**Midwest Generation, LLC**  
**Will County Generating Station**  
**Ponds 1 North, 1 South, 2 South, and 3 South Proposed Closure Construction Project**  
**Public Meeting General Summary**

This document serves as a summary of the issues and questions raised during the meeting.

MWG proposes to close Ponds 1 North, 1 South, 2 South, and 3 South in place by installing an alternate final cover system (ClosureTurf®).

# Des Plaines River Watershed Location

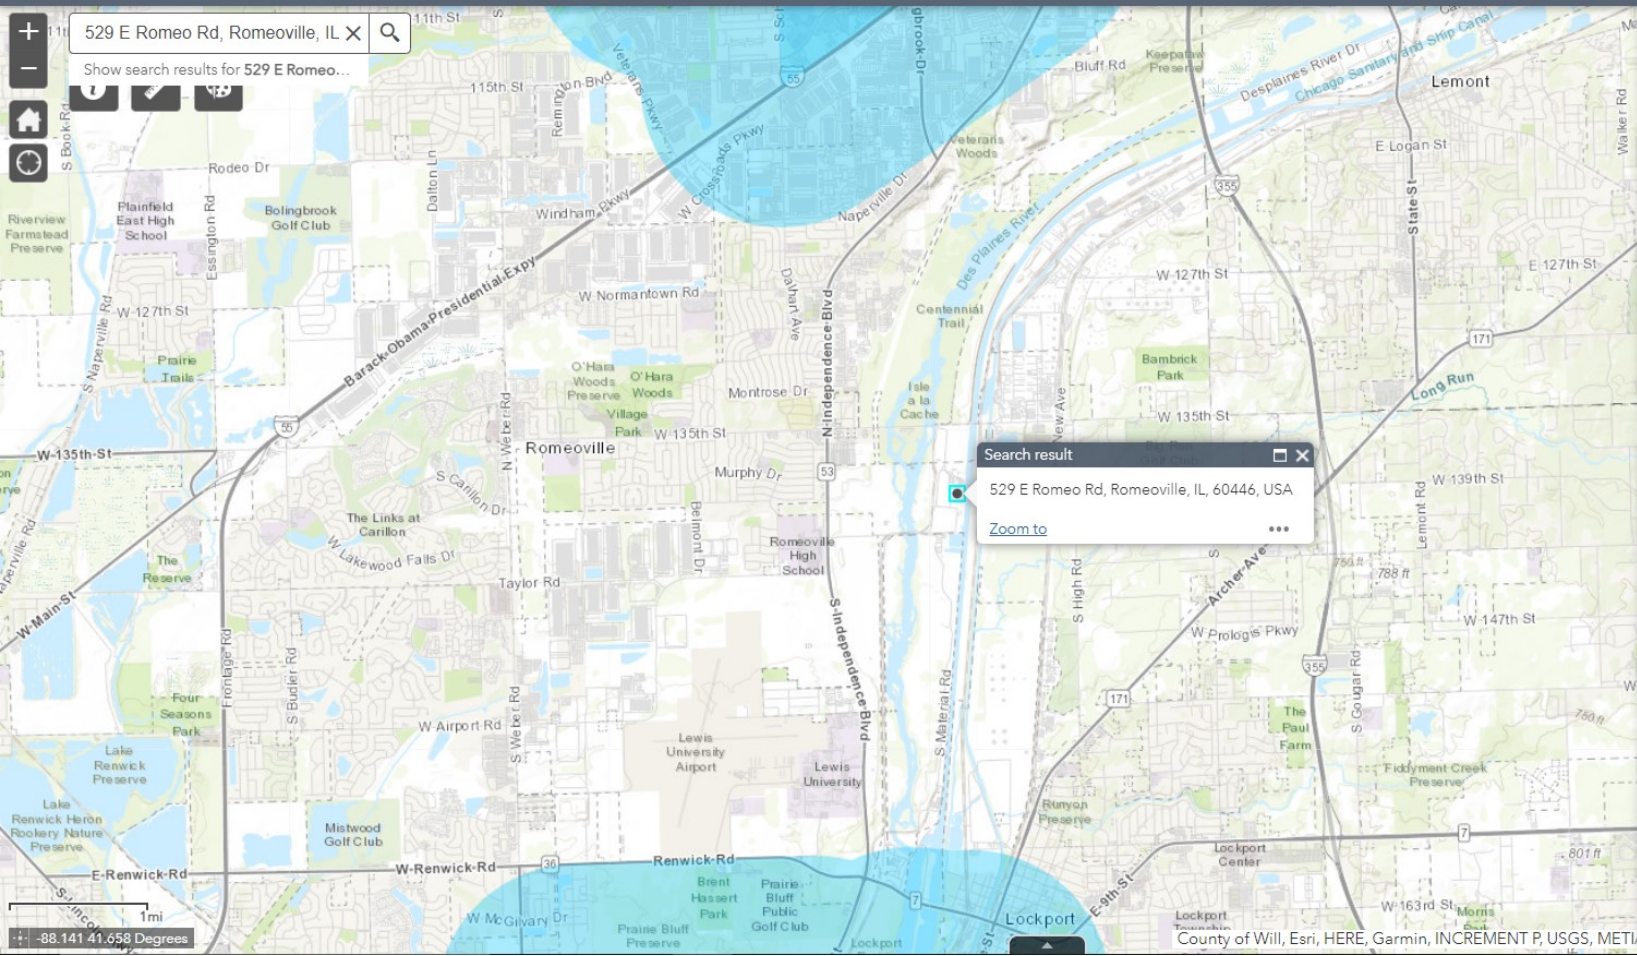
One attendee requested information on air quality and groundwater monitoring plans as well as a copy of the watershed map. The fugitive dust plan and groundwater monitoring plan are available in the Operating Permit Application that was submitted to Illinois EPA in October 2021 for Ponds 2S and 3S and March 2022 for Ponds 1N and 1S. The full application, which includes both plans, as well as the Fugitive

Dust Plan independently, are also posted on our public website: [www.midwestgenerationllc.com](http://www.midwestgenerationllc.com). A copy of the watershed map is attached to this summary.

#### GW Modeling (25 years after removal)

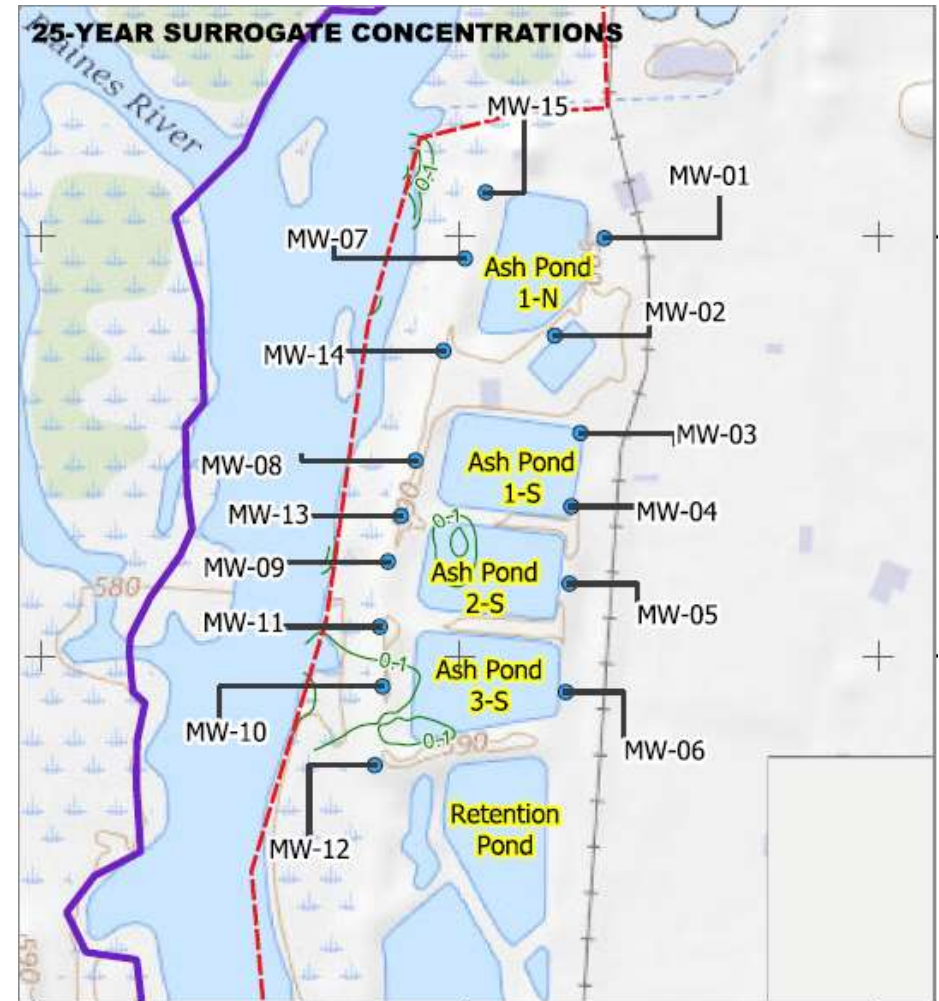
Slide 12 of the presentation had an error in the statement of the amount of time the modelling predicted it would take to achieve compliance with the 35 IAC 845.600(a) groundwater standards for the Closure by Removal Scenario. The corrected slide is attached – it will take 50 years to achieve compliance in with the 35 IAC 845.600(a) groundwater standards, the same amount of time it would take in the Closure in Place Scenario. The information is presented correctly in the Closure Alternatives Analysis (see Figure 32).

- Remove all material from basin and haul off site.
- Remove existing liner system and haul off site.
- Grade exposed base to manage stormwater.
- Limited local landfill capacity and CCR acceptance is prohibitive.
- Onsite space for a new landfill is limited, and citing would add multiple years to the project.
- Estimated quantities:
  - Area ≈ **9.5 acres**
  - CCR/material to remove ≈ **161,000 CY**
  - Subgrade fill ≈ **40,000 CY**
- **Modeled concentrations are reduced by 80% within 25 years at downgradient wells. All constituents compliant with proposed GWPS with approx. 10 years or less and below the 845.600(a) standards within approx. ~~20~~ 50 yrs.**

\*After the June 7<sup>th</sup> public meeting, MWG identified a typo on this slide. All constituents will be below the 845.600(a) standards within approx. 50 years (See Figure 32, MW-12 of the Closure Alternatives Analysis posted on MWG's website on May 9, 2023).
